SCIENCE BUILDING
LOS MEDANOS COLLEGE
Contra Costa Community College District
2000 Christmas Lane
Concord, CA 94520
Contact: Dr. Richard Lee

Date: February 1, 2006
To: S.J. Amoroso Construction, 390 Bridge Parkway, Redwood shores CA 94065
Project: LOS MEDANOS COLLEGE SCIENCE BUILDING, Contra Costa Community College District, DSA No. 01-106226 File # 7-C1, tBP PIN 20247.00
Description: REFERENCE: E-0.1, E-1.1, Submittal #20:
Provide wall mounted light Kenall #MR7FIL in locations as indicated on SKRS-07.1 to SKRS-07.5 in place of downlights at entrance canopies. Fixture is to be located +9'-0" AFF typical. Provide Re-submittal #20 for C-4.
Issued By: Architect
Requested By: Architect
Reason: Lighting coordination
Enclosures: SKRS-07.1 to SKRS-07.5
Distribution:

ADDENDUM #1
DATE: 03/08/05
DSA NO: 01-106226
THIS REVISES IN PART
SHEET: RE-0.2
SHEET: RE-2.2

Issued By: Architect
Requested By: Architect, Owner
Reason: Clarification of Automatic Door Opener Switches
Enclosures: SKA-44.1

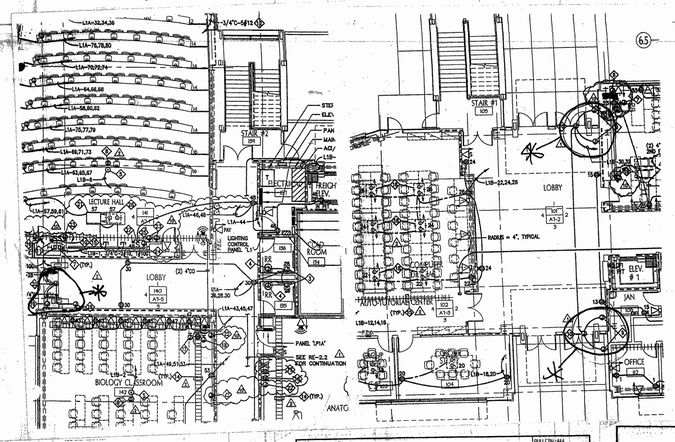
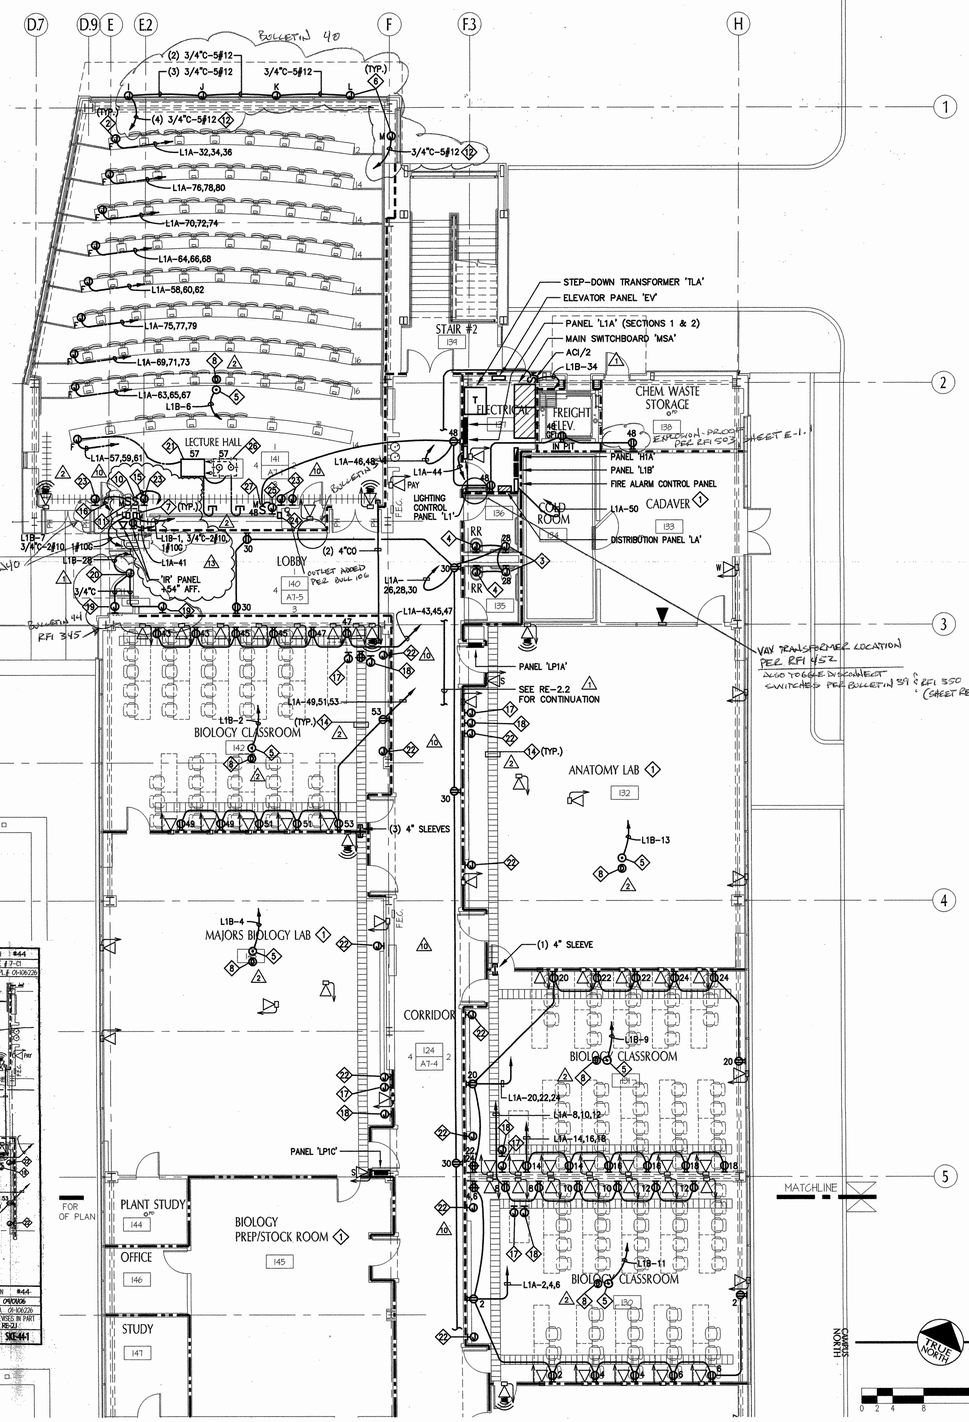
See attached SKA-44.1 for clarification to mounting height of "Automatic Door Opener Switches". In note #7&8, the mounting height is indicated to be between 30" to 44" AFF. For clarification only, mounting height of Opener Switches are to be as shown on SKA-44.1.

BULLETIN #40
DATE: 05/24/06
DSA NO. 01-106226
THIS REVISED IN PART
SHEET: RE-2.2
SHEET: SKE-40.5

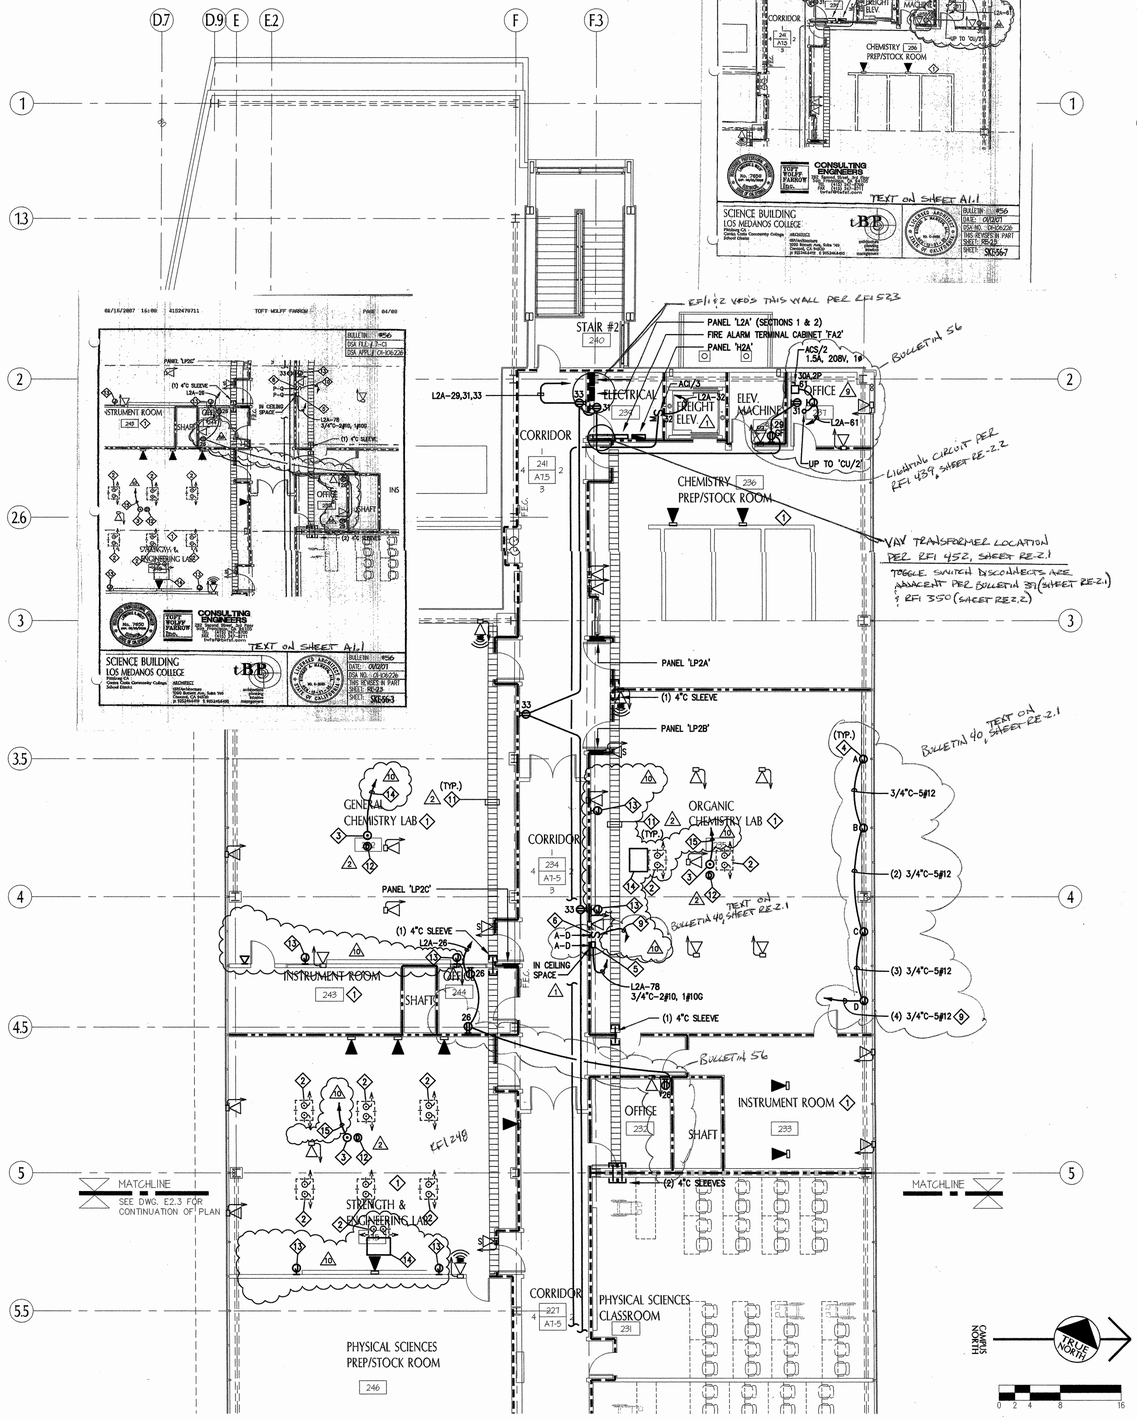
5. Refer to sketch SKE-40.5: Revised sheet notes #10 pertaining to motorized shade requirements. Provide credit to reduction of (4) junction box locations down to (2) junction box locations.

THIS REVISED IN PART
SHEET: TI-3
SHEET: SKT-100.2

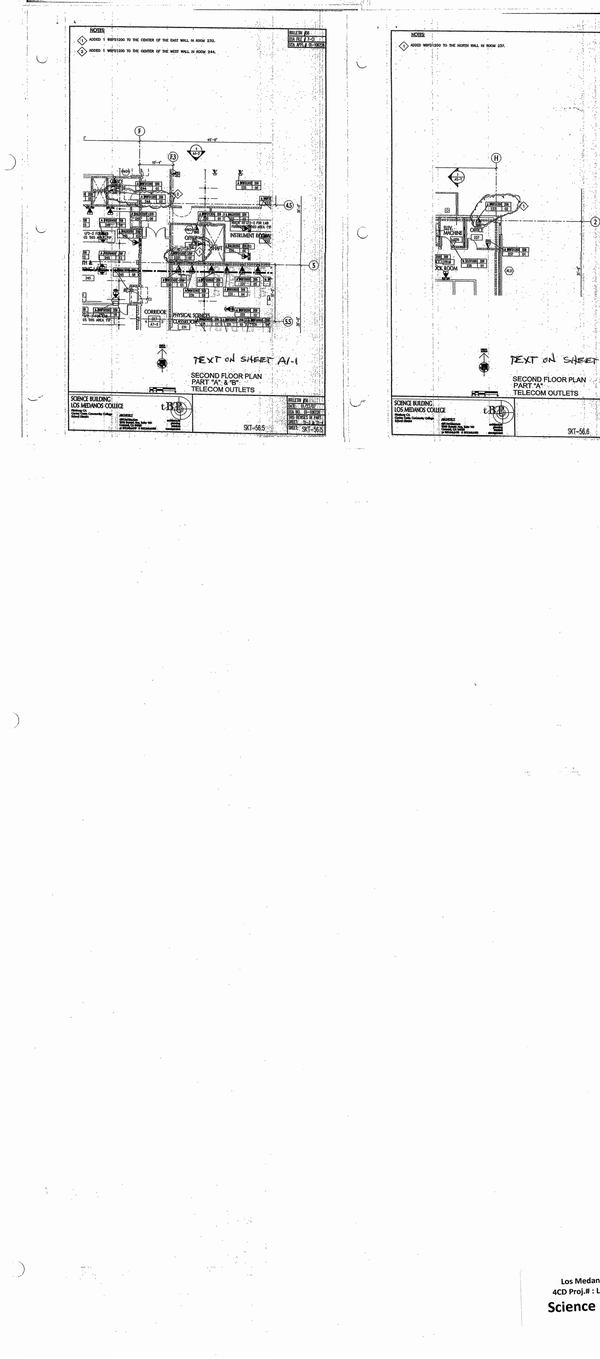
NOTES:
1 ADDED 1 WSFD1200 TO THE CENTER OF THE EAST WALL IN ROOM 330.
2 ADDED 1 WSFD1200 TO THE CENTER OF THE WEST WALL IN ROOM 344.
TEXT ON SHEET A1-1
SECOND FLOOR PLAN PART "A" & "B" TELECOM OUTLETS
SCIENCE BUILDING
LOS MEDANOS COLLEGE
SKT-56.5
NOTES:
1 ADDED WSFD1200 TO THE NORTH WALL IN ROOM 337.
TEXT ON SHEET A1-1
SECOND FLOOR PLAN PART "A" TELECOM OUTLETS
SCIENCE BUILDING
LOS MEDANOS COLLEGE
SKT-56.6
